PINEWOOD SUBDIVISION, RESUBDIVISION OF LOT 4, BLOCK 1

APPLICATION NUMBER 4 DATE August 20, 2015
APPLICANT Pinewood Subdivision, Resubdivision of Lot 4, Block 1
REQUEST Subdivision

DETAIL SITE PLAN

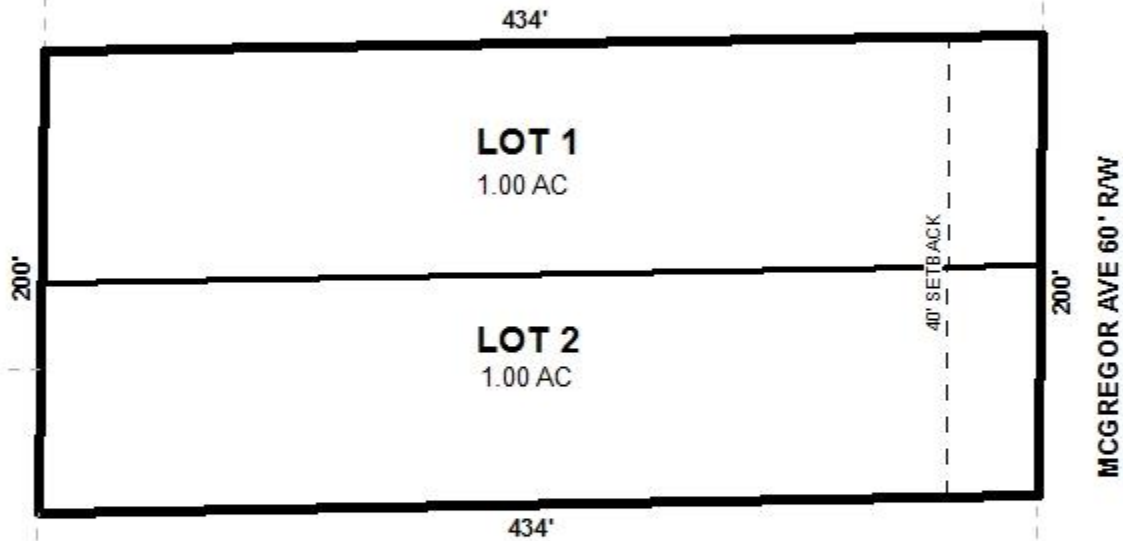
- B. Add legible street names to the vicinity map.
- C. Show and label the existing drainage easement along the rear of LOT 1 and LOT 2.
- D. Provide and label the monument set or found at each subdivision corner.

The proposed lots front South McGregor Avenue, a planned major street as shown on the Major Street Plan Component of the Comprehensive Plan with an existing right-of-way width of 60 feet. Due to the atypical nature of South McGregor Avenue, a minimum right-of-way width of 80 feet is required as opposed to the standard 100 foot right-of-way width normally required of most major streets. The Final Plat, if approved, should be revised to reflect dedication sufficient to provide 40 feet from the centerline of South McGregor Avenue.

The preliminary plat depicts a 40-foot minimum building setback. Any setback line must be a minimum of 25 feet from the edge of the right-of-way, and in this case, should reflect the required dedication of right-of-way.

Aerial images appear to depict an existing dwelling located on the lot, straddling the proposed interior lot line. Documentation must be submitted to illustrate the removal of the dwelling by means of a demolition permit prior to the signing of the Final Plat.

The proposed lot sizes are provided in square feet and acres for each lot, and would exceed the minimum required lot size in Section V.D.2. of the Subdivision Regulations. This information should be revised to reflect right-of-way dedication and retained on the Final Plat, if approved.

- 1) Dedication sufficient to provide 40 feet from the centerline of South McGregor Avenue;
- 2) Obtainment of a demolition permit for the existing dwelling prior to the signing of the Final Plat;
- 3) Illustration of a 25 foot minimum building setback line along South McGregor Avenue for each lot, reflecting right-of-way dedication;

- 4) Placement of a note on the Final Plat, stating that Lots 1 and 2 are limited to one curb cut each to South McGregor Avenue, with the size, location and design to be approved by Traffic Engineering and conform to AASHTO standards;

- 5) Retention of the lot size in square feet and acres on the Final Plat revised for dedication;
- 6) Compliance with Engineering comments (*The following comments should be addressed prior to submitting the FINAL PLAT for acceptance and signature by the City Engineer:*
